DSOX4054A-01

S E R V I C E N O T E

4000 X-Series Scopes

A replacement of the power supply cover is needed when the cabinet assembly is replaced.

New revision cabinet assembly (54709-64401)

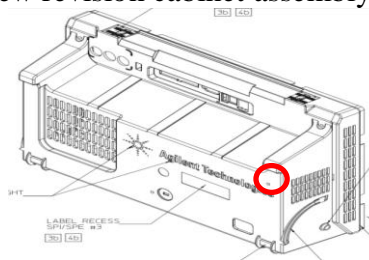
If the cabinet assembly requires a replacement, also replace the power supply cover in order to become compatible with the new revision of cabinet assembly and become compatible with zipper pouch attachment.

1. If the cabinet assembly (54709-64401) needs to be replaced, check if it is the old revision or the new revision
 - a. Old revision has 3 screw holes
 - b. New revision has 4 screw holes

2. If the cabinet assembly is the new revision, proceed with repair as normal
3. If the cabinet assembly is the old revision
 - a. Replace the power supply cover (54695-00103) with new revision
 - b. Replace cabinet assembly as usual (54709-64401)
 - c. Insert screw (0515-0380) into the new screw hole on the cabinet assembly (circled below)
